A12 Chelmsford to A120 widening Supplementary consultation November 2021

Why are we having a supplementary consultation?

Design presented at statutory consultation with access to Easthorpe Road

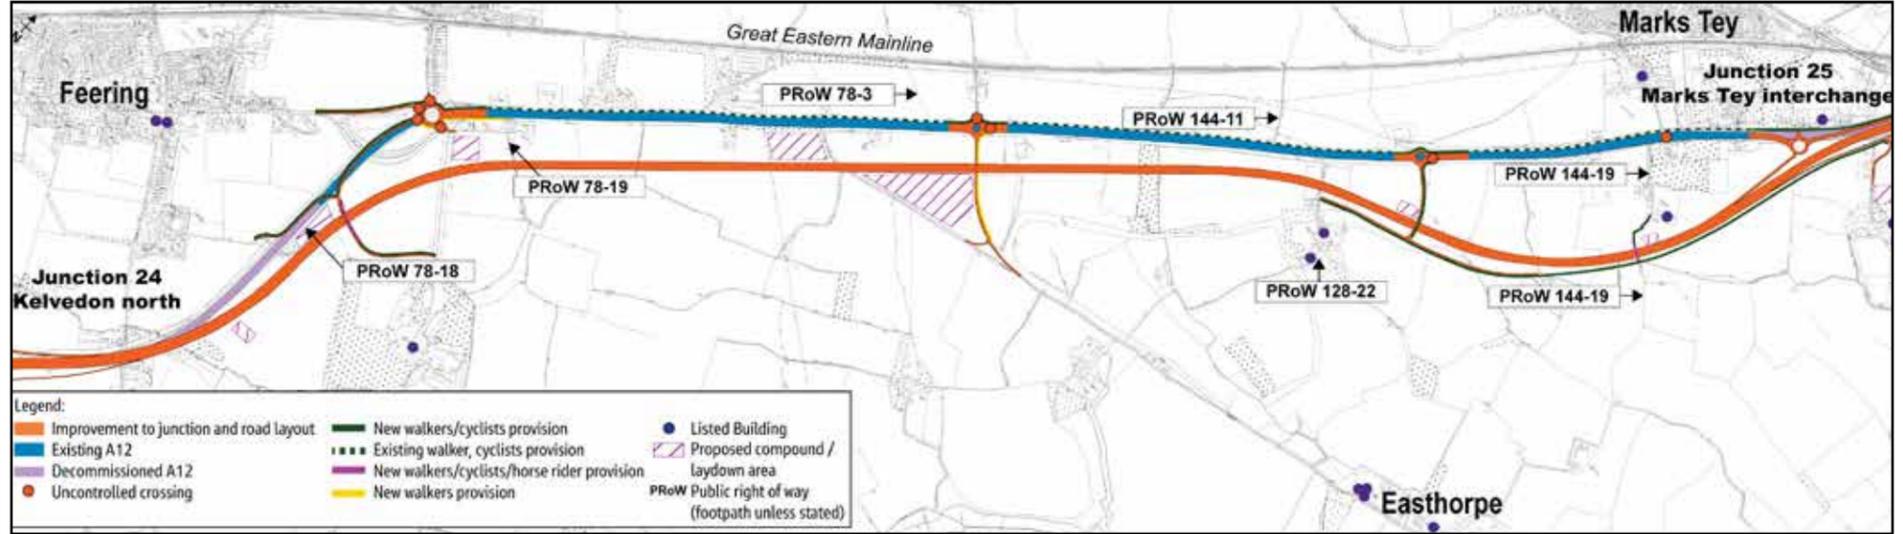
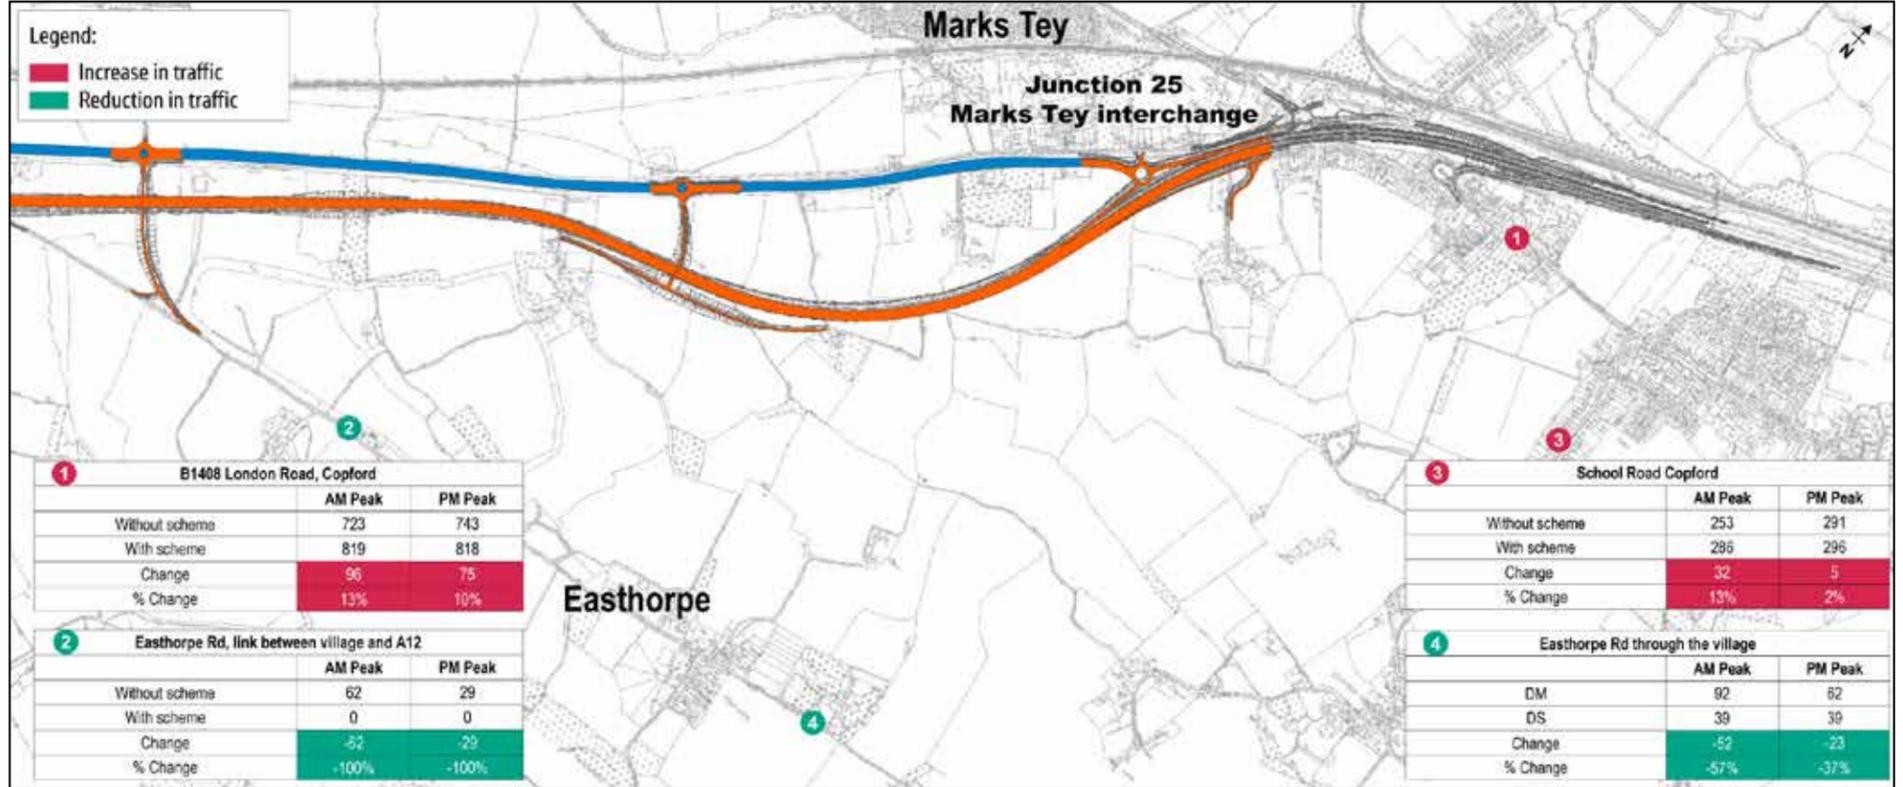
In our statutory consultation, as presented in the map below, we showed proposals for improved access to Easthorpe Road from the existing A12 once it is bypassed and becomes a local road. The design presented at statutory consultation allowed drivers to use the new roundabout to access Easthorpe Road from both sides of the existing A12 and cross over the A12 bypass via a new bridge.

In response to our consultation proposals, we received a lot of concerns about the improved access arrangements we were proposing, and feedback that the access should be closed. These concerns referred to the increase in traffic predicted for Easthorpe Road. Considering the concerns, we reviewed the access arrangements at this location and concluded that the access could be closed.
